Dan McKeel GSI SEC-105 Co-Petitioner Comment to NIOSH Docket 140 (GSI)
(August 5, 2012)

TO: Advisory Board on Radiation and Worker Health Work Group on TBD-6000 FROM: Robert Anigstein, Stephen Marschke, and John Mauro, SC&A SUBJECT: Alternative Model for the Calculation of Uranium Intakes at GSI DATE: July 25, 2012

Alternative Model for the Calculation of Uranium Intakes at GSI

Figure 1. Locations of α -Activity Measurements in Old Betatron Building

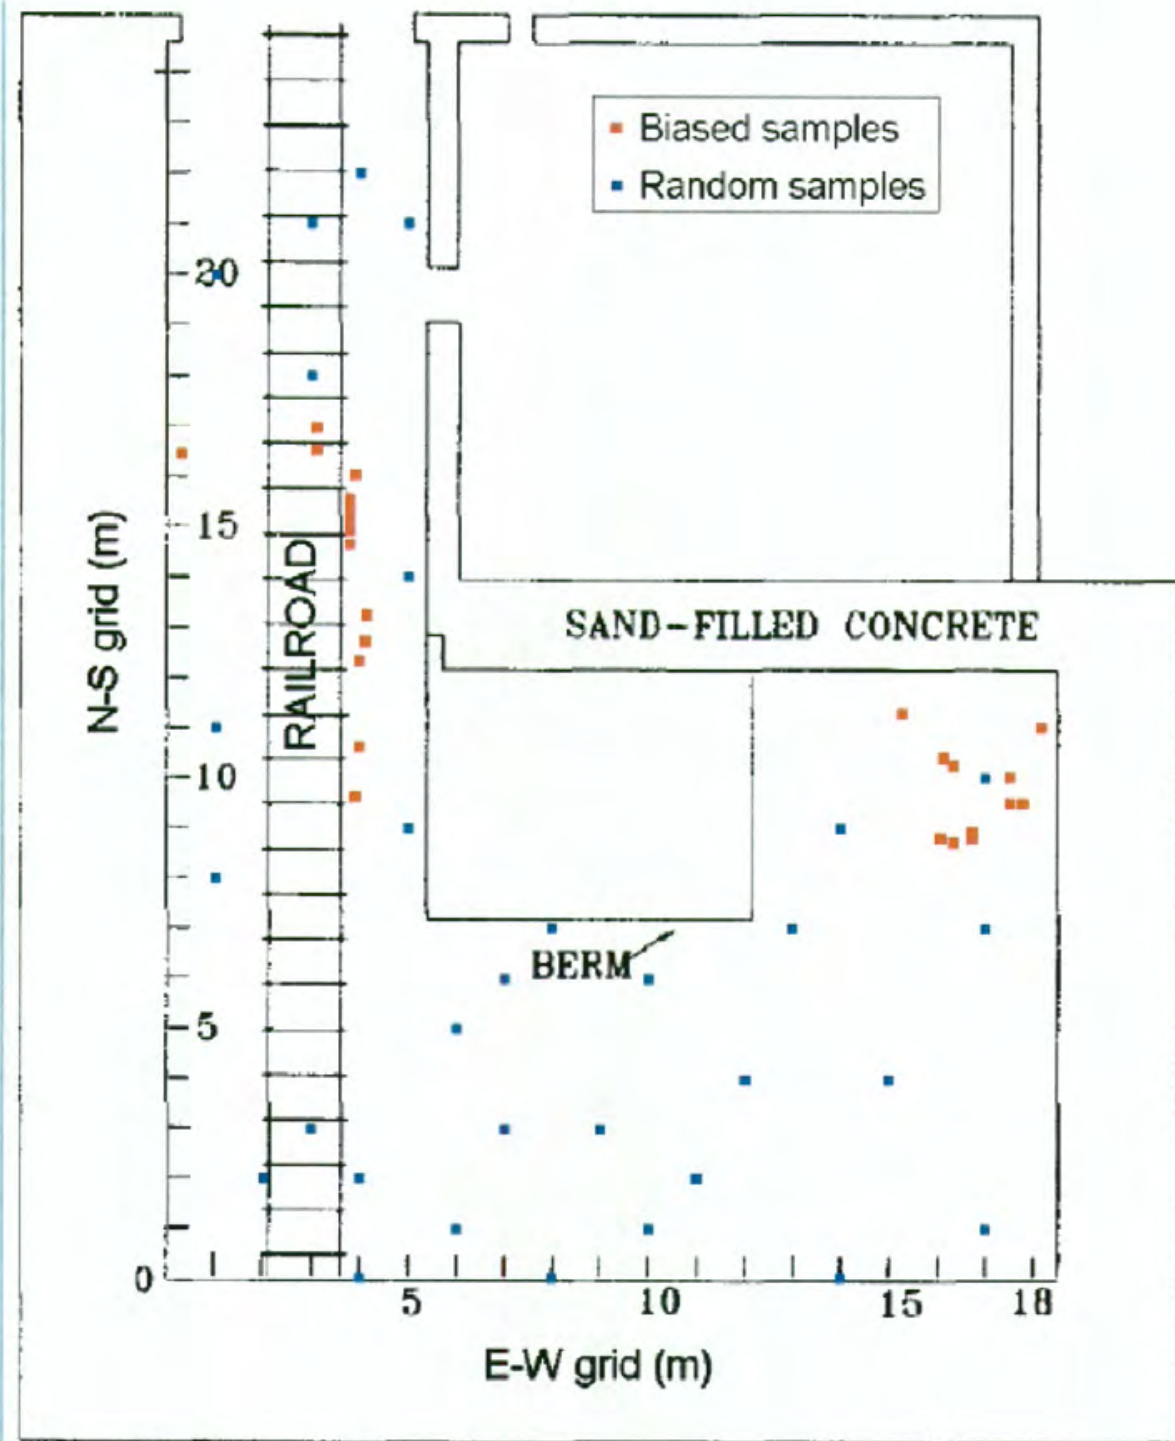
1. OLD BETATRON BUILDING. As Dan McKeel, GSI co-petitioner explained at length at the June 14, 2012, TBD-6000 work group meeting, the petitioner's view is that the tiny amount of uranium dust data collected by ORNL for DOE for the GSI Old Betatron facility at the end of the residual contamination period bears essentially no relation to radioactivity in 1974 at the start of the residual period or at any time during the residual period except on the October day in 1993 when the ORNL-DOE alpha and beta measurements were made.

The uranium detected in 1993 in the Old Betatron shooting room is clearly not representative of the entire residual period or of an undisturbed decay of uranium. So to mathematically calculate an assumed dose for each year from 1953 to 1993 at GSI is completely absurd. It is unreasonable to assume *a priori*, without measured data to back it up, that radiation levels declined in a smooth arc, whatever type of curve fitting decay formula one chooses to use in the model. The model is flawed from the outset because accurate, comprehensive, real measured data for 1953 to 1993 from throughout the GSI building complex to validate and define and bound doses using the alternate uranium intake model is simply not available. The model is surrogate data based.

The statement starting on the fourth line from the bottom of page 3 of the SC&A alternate model report that *"These random samples constitute the best available data for estimating the average contamination level on the floor of the shooting room of the Old Betatron Building,"* may be true but is also a bit misleading and disingenuous because (a) these are the only such data, and (b) they were taken 40 years after the start of the covered period and 20 years after the start of the residual contamination period. Uranium dust can and often does settle on building rafters as well as on the floor (see Dow Madison SEC-00079 petition Board deliberations for more discussion of this point). The GSI Old and New Betatron rafters were not surveyed for uranium dust radiation during the cleanup in 1993. Why this was *not done* is hard to understand.

Figure 2. Elevation Drawing of New Betatron Building—Detail (NRC 2009)

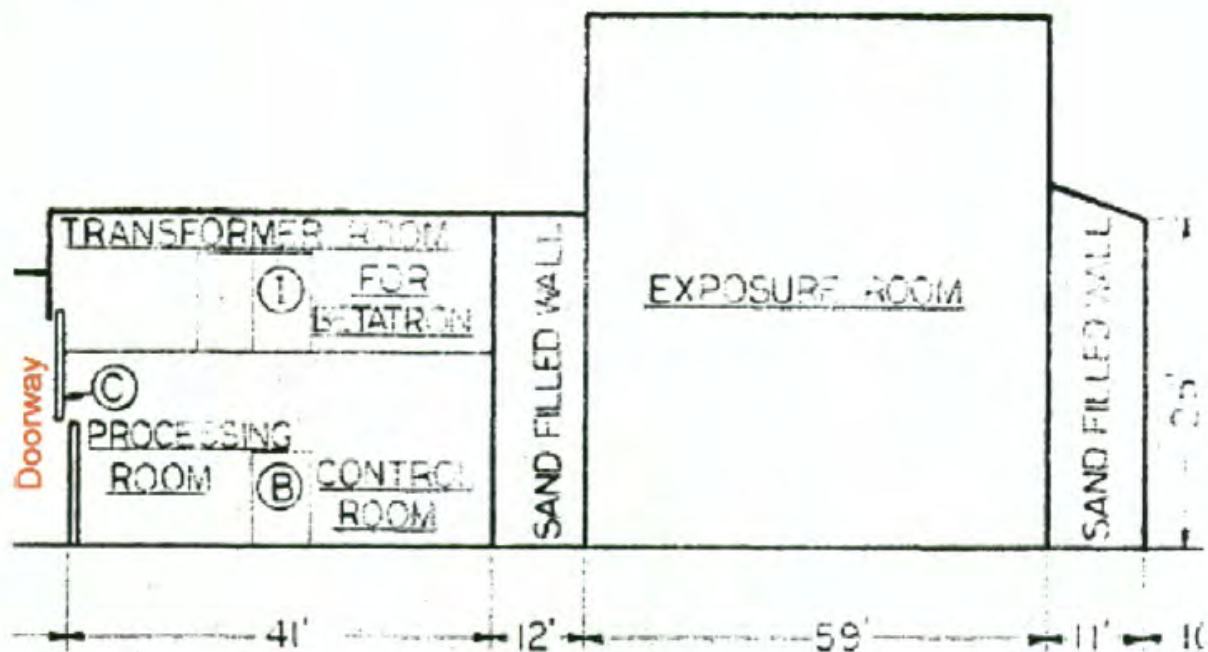
1. The New Betatron Building elevation drawing cannot be used to calculate a building dimensional model. Note the height of the control room is not shown. This is a side view sketch, not a blueprint and the doorway dimensions are not given. Nothing is to exact scale. One sand filled wall is said to be 11 ft. thick and the other 12 ft. thick, which makes no sense based on other drawings we have of the same structure. What one can see is the different height between the exposure room and the tunnel to the left is much larger for the New Betatron Building than it appears to be for the Old Betatron Building pictured below.

Figures 2 and 3 are thus entirely worthless for making any definitive statements about building volumes and dimensions. No one has made any serious attempts to obtain engineering drawings, including "as built" plans from the Army Corps of Engineers or from GSA, which sold the Old Betatron building and contents in 1974 as it was government owned.
